UNSW Peer Review Terms of Reference

1. Conduct a peer review of the groundwater impact assessment, in particular, the supporting groundwater modelling work. Determine whether the modelled aquifer extents were adequate and consistent with the available bore logs and the transient electromagnetic survey data.
2. Comment on the adequacy of the existing reviews of the groundwater modelling commissioned by Shenhua, NSW Office of Water, the Independent Expert Scientific Committee and NSW Planning.

Documents Reviewed for the NSW Irrigators Council:

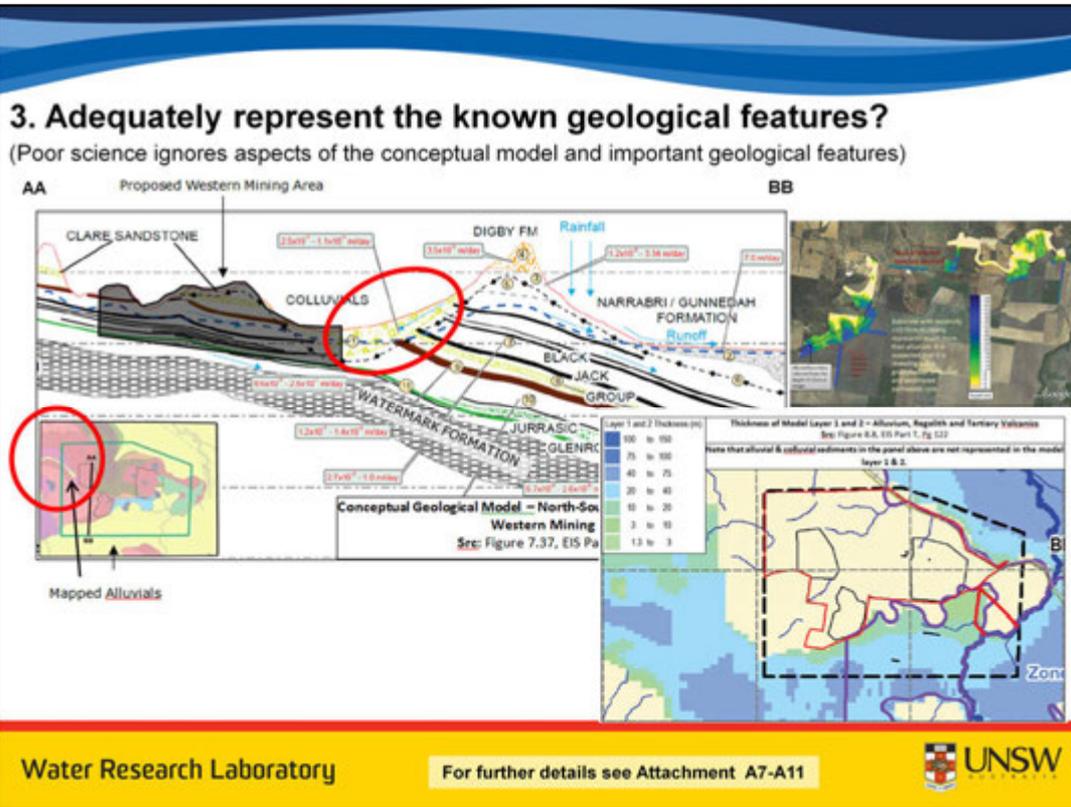
As my colleagues from UNSW have shown repeatedly in the literature, reality is a more complex distribution of clays, silts, sands and gravels deposited over 2.5 million years. So how do you adequately represent all that in a two layer model? And the answer is, in close proximity to a mine body, you just can't (as the previous slide).

Furthermore, when I inspected layers 1 and 2 of the Shenhua's numerical model shown here at the bottom right of the screen I noted that it did not represent any alluvium or colluvium in the cream coloured areas about the proposed mine, despite such features being clearly identified on GHD's conceptual model circled here in red to the left (yellow channel) and top of the slide (marked layer 1) and also in the results of a geophysical survey shown top right. Where did these features go to in the model?

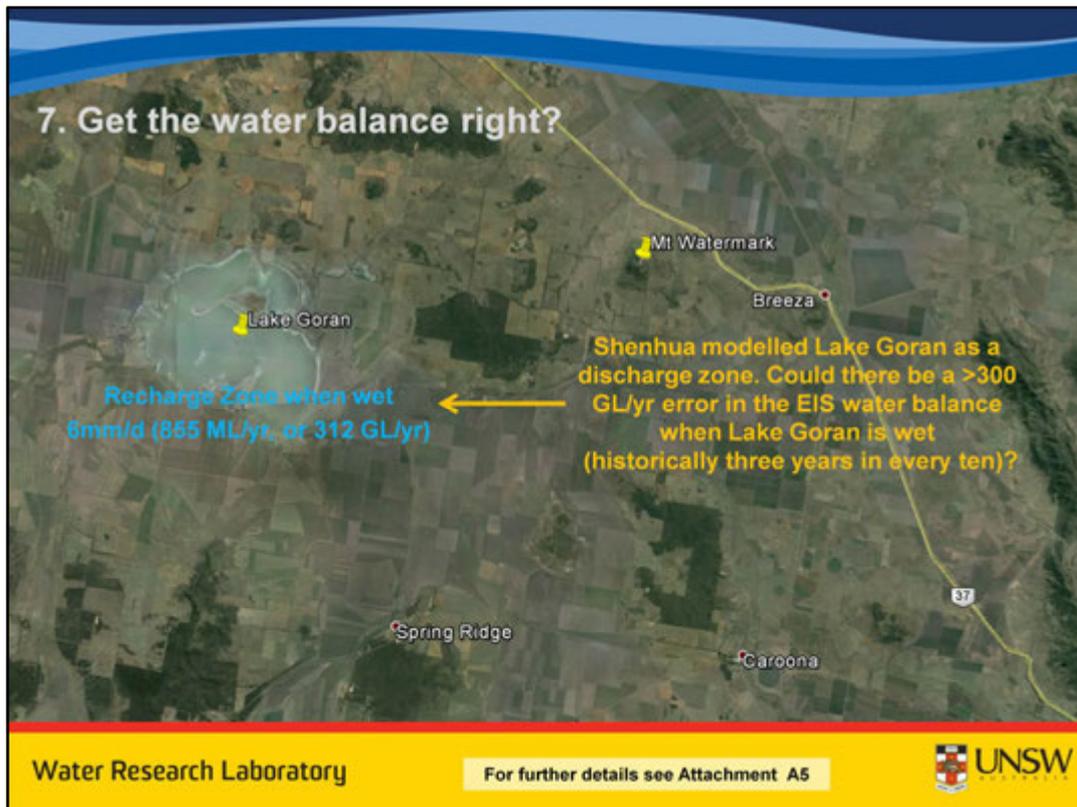
The blue and red dots on this first figure here show all the groundwater bores which could have been used to calibrate the groundwater model. As you can see, there are a number of bores. This second panel here shows the data that was actually used. With so few bores and how can a calibration to this data be accurate and adequate? It simply can't.

And as demonstrated by the next figure in the EIS you can see that the model under-predicts groundwater levels by 10-20m to the north of the mine, possibly because paleochannels have been ignored and because faults have been simulated inappropriately. To the south of the proposed mining area here you can see the model over-predicts groundwater levels by up to 20m, possibly because this is the area where permeable colluvium and alluvial channels were not represented in model layers a 1 and 2. Of course there are other possible reasons but the EIS forgot to mention these ones. That is not good science.

Figure 7.3 – EIS Part T

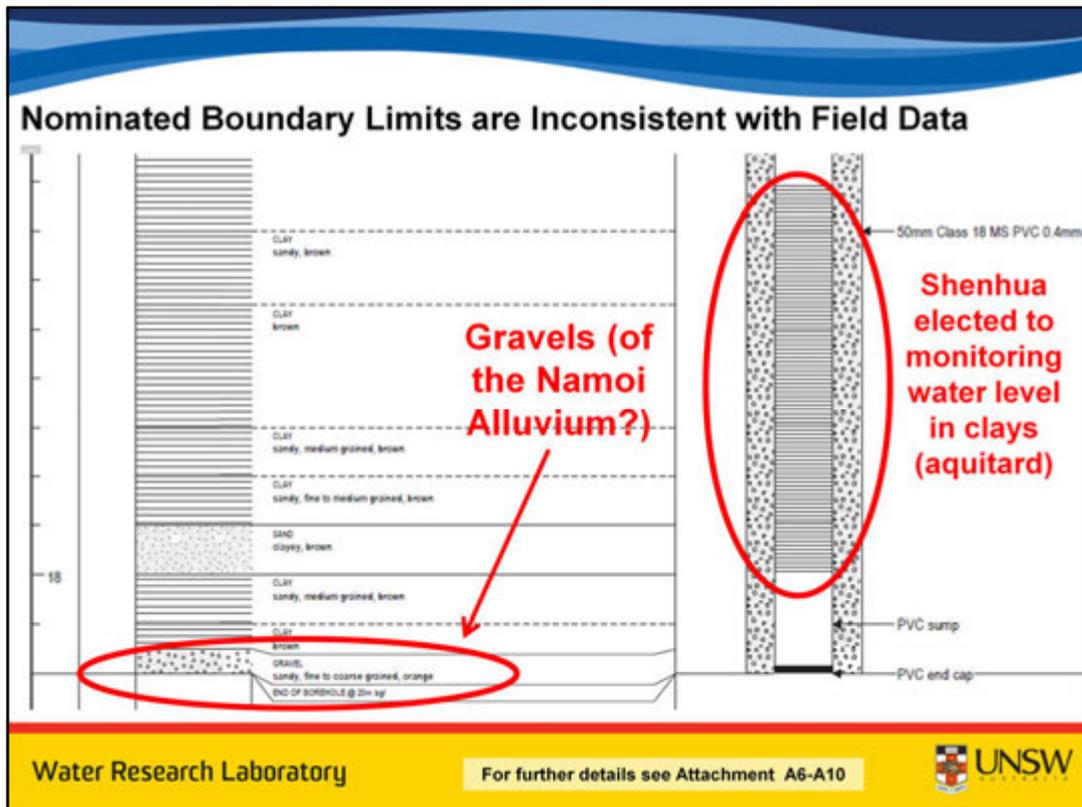
The proponent's response to this requirement was this text on page 40 of the EIS and the provision of figures 7.3 and 7.4.

You will notice that this text contains no justification of the boundary, no reference to a geological modelling assessment report, no reference to mapping of the sands and gravels in the Narrabri Formation and no mapping of sands overlying sandstones which occur close to the proposed mine. The referenced GHD report is also not published or exhibited for verification.

Furthermore, the report does not adequately address the findings of Shenhua's own geophysical survey and bore-logging data which appears to be in direct conflict with the presentation in Figure 7.3. Shown here on the screen is just one example from bore WM00365 on page 589 of the EIS.

So where is this hole? It is located here on Figure 7.3 as shown by the green arrow. Why therefore, does Figure 7.3 not show the colourful Namoi Alluvial aquifer contours extending to at least this point?

There are numerous other pieces of data in the EIS which point to Figure 7.3 being incomplete and I am concerned the EIS has failed to adequately address an essential government requirement.

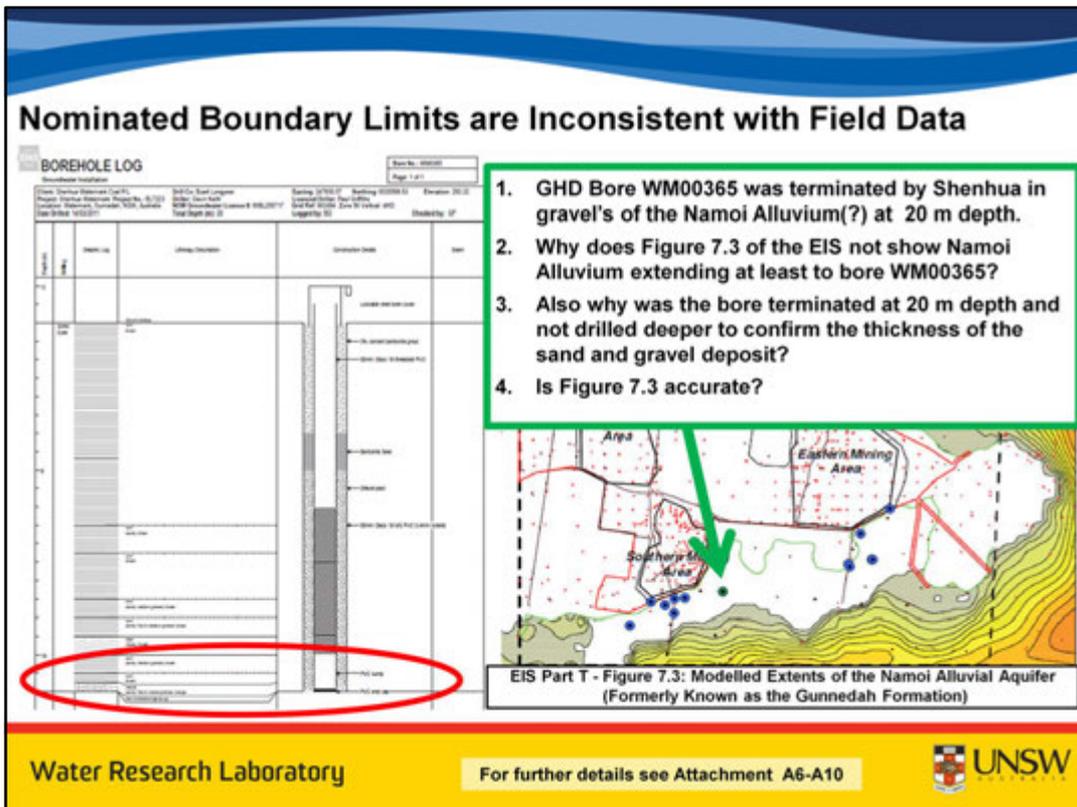
Note how at the very bottom of the log after reaching sandy gravel, the hole was terminated (is this alluvium or colluvium?)

EIS Part T - Figure 7.3: Modelled Extents of the Namoi Alluvial Aquifer (Formerly Known as the Gunnedah Formation)

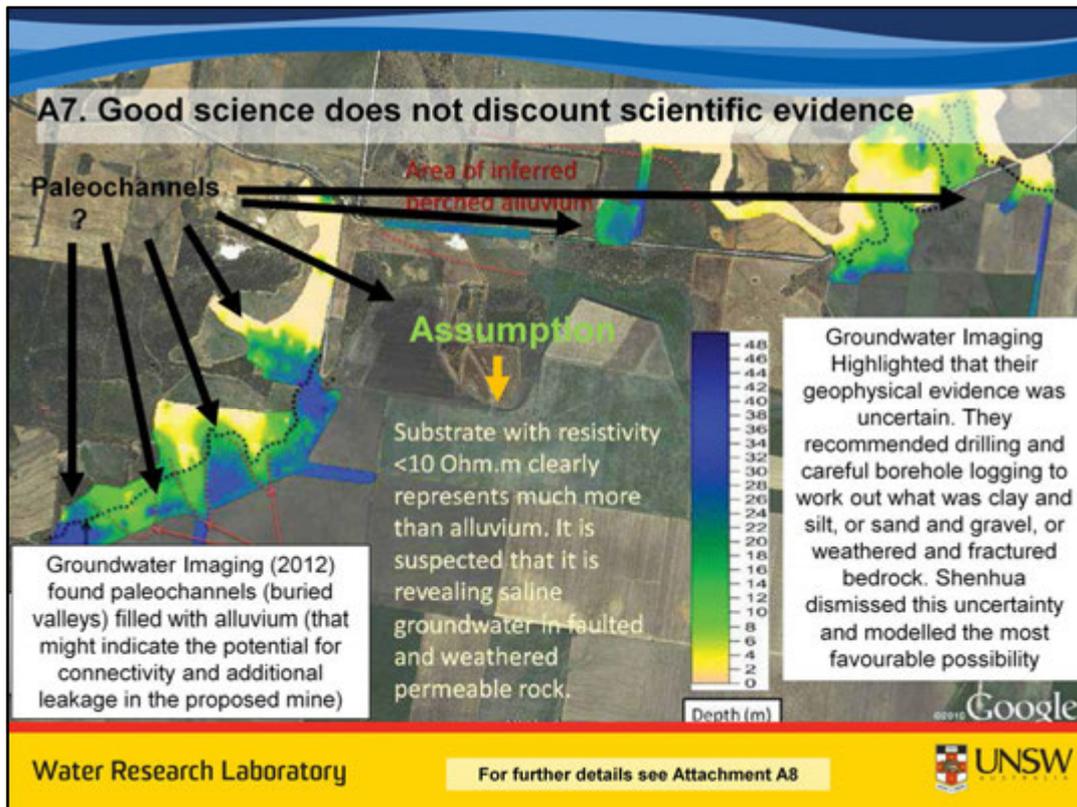
The elevations of the alluvial deposits in the bores shown in blue are consistent with elevations of the sands and gravels of the Gunnedah Formation mapped here.

Why therefore was the aquifer not modelled closer to mine boundary?

Where is the report justifying Figure 7.3 of the EIS? If the aquifer is closer the model under-predicts impact.

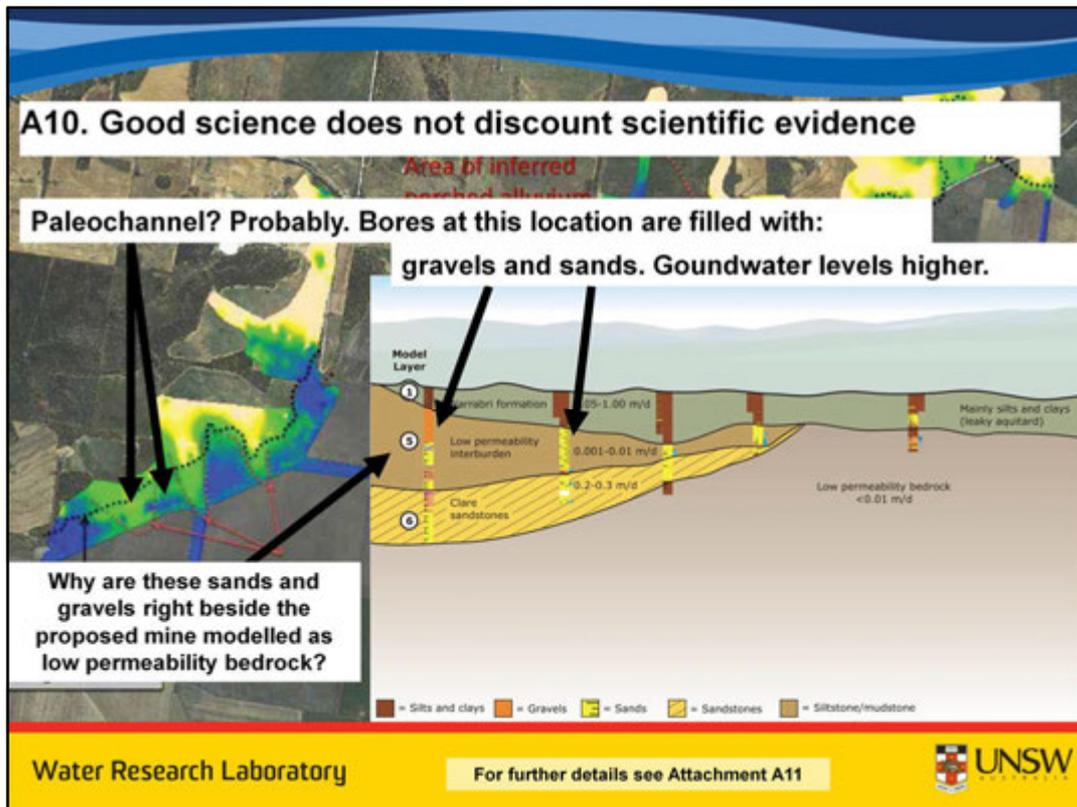
This figure demonstrates that elevated groundwater levels were found in bore WM0429 by GHD which is less than 250 m away from the proposed southern mining area. The location of WM0429 corresponds with one of the potential paleochannels identified by Groundwater Imaging. Is this evidence of an aquifer being located less than 1.3km away from the Namoi Alluvial aquifer, contrary to Figure 7.3 of the EIS (See Attachment A6)? See Attachment A10 for further evidence of this potential aquifer.

This slide shows that WM0429 and WM0421 contain gravels and sands and these are (generally) both excellent aquifer materials. Therefore, it would appear that the geophysical survey work of Groundwater Imaging has detected permeable paleochannels extending to within approximately 250m of the mine and possibly right to the edge of the current mine layout at other locations. This is at odds with Figure 7.3 of the EIS (refer Attachment A6) which suggests the aquifer is 1.3km away. Attachment A10 shows the location of this cross section and a close up of the extents of the Namoi Alluvium (formerly known as the Gunnedah Formation) as mapped by Shenhua.

A12. Shenhua's Conceptual Model (XS1)

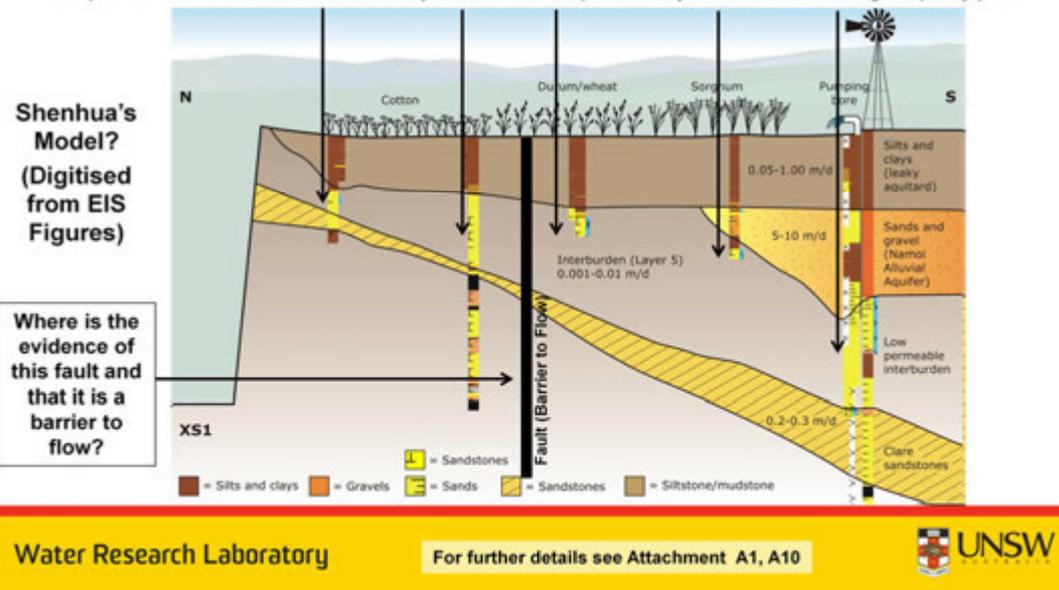
Why are there no scale geological cross sections in the EIS?

Were permeable sands and sandstones really modelled as low permeability bedrock? Or is EIS figure quality poor?

The numbers on this figures with units of m/d are the modelled hydraulic conductivity values for the numerical model layers. All data in this figure was digitised from the EIS and/or from the NSW Office of Water PINEENA database. The reviewer acknowledges some uncertainty in the plotted elevation of the formations in cross section. This is because the quality and resolution of the plan view model layer figures are of low quality with contour intervals of 50 m which is too coarse.
